**SIB 46 01 14****SERVICE ACTION: Fairing Side Panel Attachment - Bulletin 46 001 14 (023)R**

**Subject:** Fairing Side Panel Attachment

**Model:** S 1000 R (K47)

Illustration: Position of the poorly bonded Pin (1)

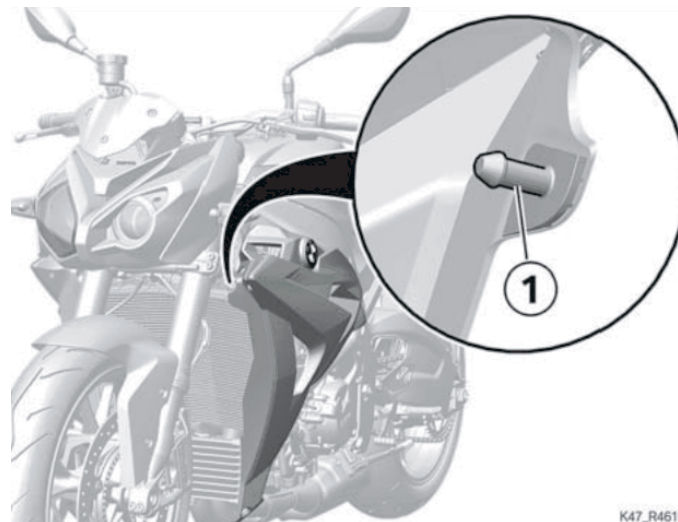
**Details:** BMW Motorrad has ascertained that on account of poor bonding, the front fairing side panels mounting pin can come loose when the vehicle is ridden at high speed. This could allow the slipstream to push the fairing side panels out, away from the frame. Note: The side panels are also held by threaded fasteners, which would keep them attached to the vehicle.

**Aftersales Solution:** Before handing over a new vehicle to its owner or when vehicles possibly affected by this issue are next brought to the workshop, re-work the mounting points of both fairing side panels (see attached work item 00 60 295 for details).  
Replace the side panel if the pin has already come loose. See current RSD (Repair and Service Data BMW Motorrad) DVD for details.

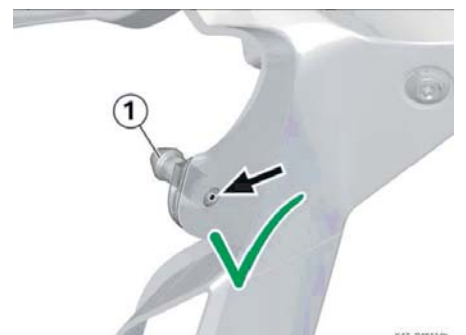
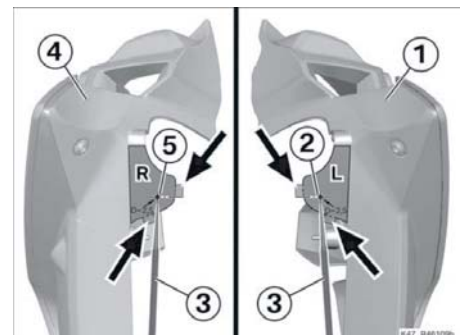
Lay templates, left (L) and right (R) on the appropriate side panel, left (1), right (4).

Make sure templates lay flat, then bend over tabs (arrows).

Mark the center, left (2), right (5) where the hole will be drilled with a suitable tool (3), such as a center punch, aligning punch, etc.

The mark (arrow) must be centered relative to mounting pin (1).

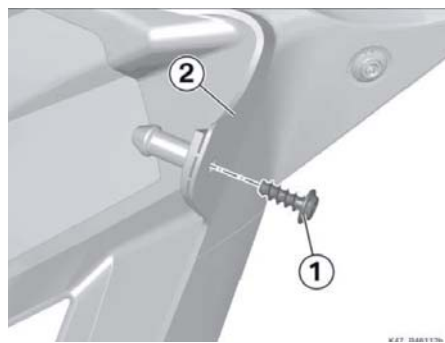
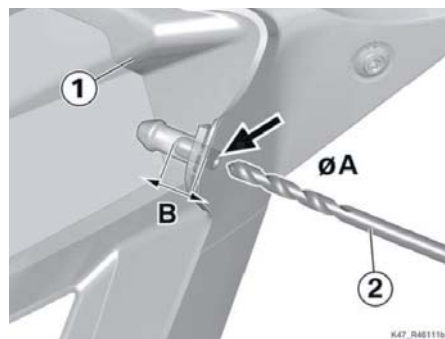
**2 continued:** At the mark (arrow), drill a hole in a fairing side panel (1) with drill bit (2) diameter (A), to depth (B).

Technical data	
Drill bit (2) diameter A	2.5mm
Hole depth B	15mm

Install screw (1) in the fairing side panel (2) until screw head is seated.

Replace old rubber grommets (1) on left and right with new rubber grommets (1).
